REFERENCE	NI_2014_X98CUP_01_UK
DATE	3rd February, 2014
SUBJECT	OFFSEASON Information

CONCERNED : ALL CHAMPIONSHIPS

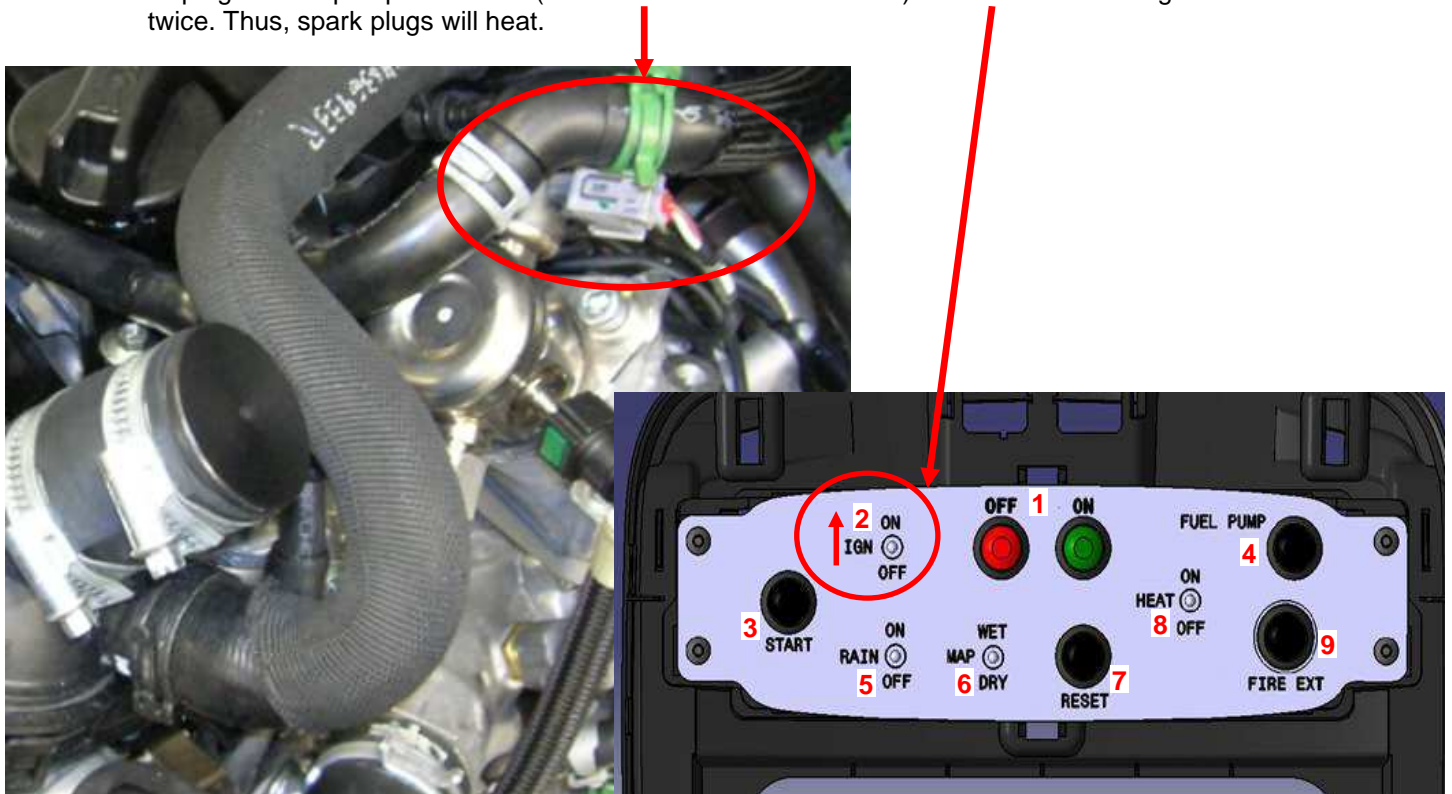
Following customer comments regarding the difficulty to start the car in cold condition, we would like to advise you about the correct cold start procedure:

1. Be sure that the battery is fully loaded. For the first start, you can place a jump battery to help on-board battery.
2. Unplug the HP pump command (connector circled in red below) and switch ON the ignition command. START twice. Thus, spark plugs will heat.

3. Plug the HP pump and start. Using cleaned or new spark plugs will help you to start properly.
